Model: CMY-MF1c/d		Date: 14-Mar-19	No.: RD0AP002
Subject: Cannot log in during the daylight-saving time		Prepared by: Y.Tamaoka	
From: Overseas Field Info Sec., OP/OS PQM Dept			
Classification:	<input checked="" type="checkbox"/> Troubleshooting	<input type="checkbox"/> Part information	<input type="checkbox"/> Action required
	<input type="checkbox"/> Mechanical	<input type="checkbox"/> Electrical	<input type="checkbox"/> Service manual revision
	<input type="checkbox"/> Paper path	<input type="checkbox"/> Transmit/receive	<input type="checkbox"/> Retrofit information
	<input type="checkbox"/> Product Safety	<input type="checkbox"/> Other ()	<input type="checkbox"/> Tier 2

Model: CMY-MF1cM/dM		Date: 14-Mar-19	No.: RD0AP003
Subject: Setup procedure at the first power up		Prepared by: Y. Tamaoka	
From: Overseas Field Info Sec., OP/OS PQM Dept			
Classification:	<input checked="" type="checkbox"/> Troubleshooting	<input type="checkbox"/> Part information	<input type="checkbox"/> Action required
	<input type="checkbox"/> Mechanical	<input type="checkbox"/> Electrical	<input type="checkbox"/> Service manual revision
	<input type="checkbox"/> Paper path	<input type="checkbox"/> Transm

[A]: User installation start-up screen

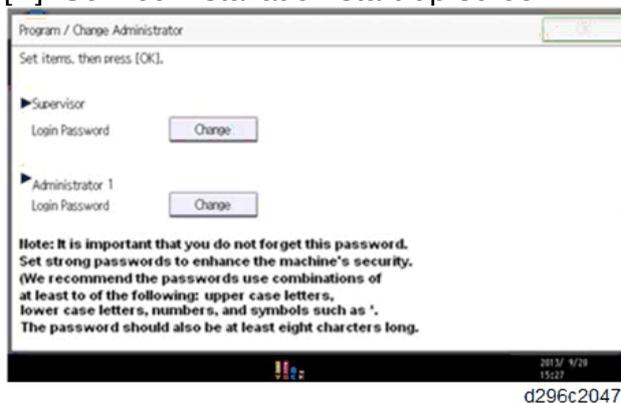
The start-up screen for user installation [A] (instead of for service installation [B]) appears when the machine is first powered up at installation, even though the machine is a service-installed model.

The initial machine settings are correct from the end of March 2019 production.

Follow the regular procedure for user installation.

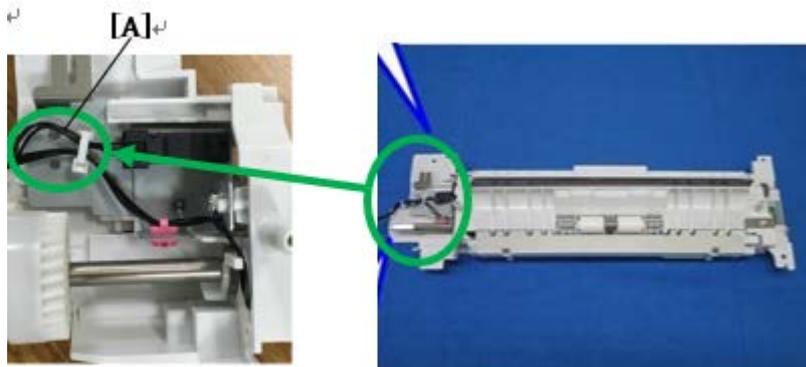
Noise occurs around Bypass feed upper cover.

Contact with the harness for Bypass Paper End Sensor [A] and clutch gear.

Replace the harness with P/N: D0A45325

Old P/N	New P/N	Description	Q'ty	Int
D0A45314	D0A45325	HARNESS:BICU:TRANSPORT SECTION:MANUAL FEED SECTION	1-1	x/O

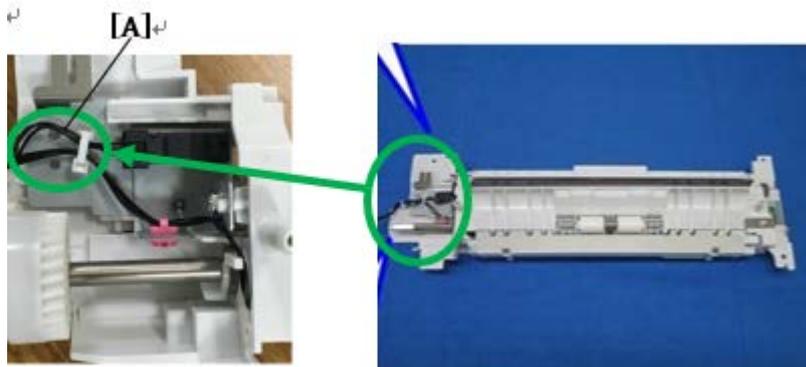
Noise occurs around Bypass feed upper cover.

Contact with the harness for Bypass Paper End Sensor [A] and clutch gear.

Replace the harness with P/N: D0A45325

Old P/N	New P/N	Description	Q'ty	Int
D0A45314	D0A45325	HARNESS:BICU:TRANSPORT SECTION:MANUAL FEED SECTION	1-1	x/O

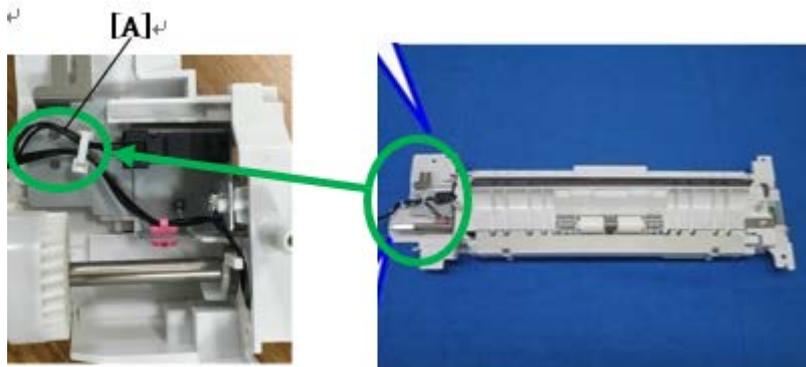
Noise occurs around Bypass feed upper cover.

Contact with the harness for Bypass Paper End Sensor [A] and clutch gear.

Replace the harness with P/N: D0A45325

Old P/N	New P/N	Description	Q'ty	Int
D0A45314	D0A45325	HARNESS:BICU:TRANSPORT SECTION:MANUAL FEED SECTION	1-1	x/O
